## NOTICE TO ALL FIRMS

Re: Addendum Number 1  
IFB # C1585R – Pomerantz New Fire Alarm System – Rebid

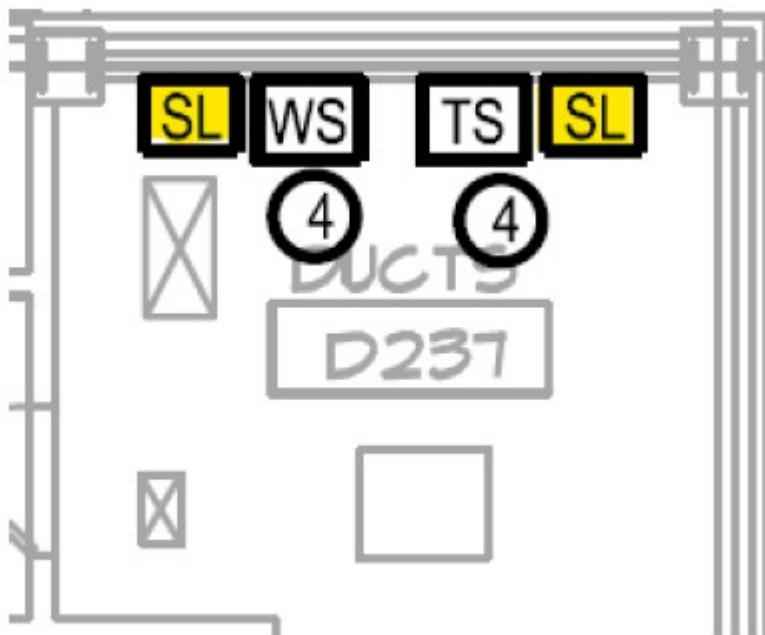
Q2. Drawing FA-001 General Notes#21 states that Wiremold is permitted to be used in finished areas for fire alarm wiring in exposed or below 8FT, can EMT conduit be used in Lieu of Wiremold? Please advise.

A2. EMT is permitted to be used in lieu of Wiremold. Any EMT used in exposed areas must be painted to match the wall finish.

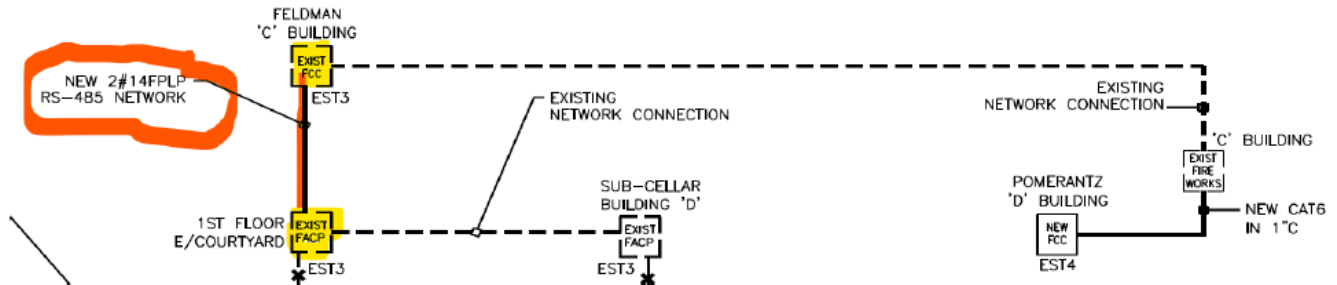
Q4. FA-102: Room D237 shows (2) Strobe Light Symbols next to the Water/Tamper Flow switches, please advise if this is to be Control Modules instead of Strobe Lighting Units? See below.

A4. These are intended to be control modules as required by the riser diagram on drawing FA-601.
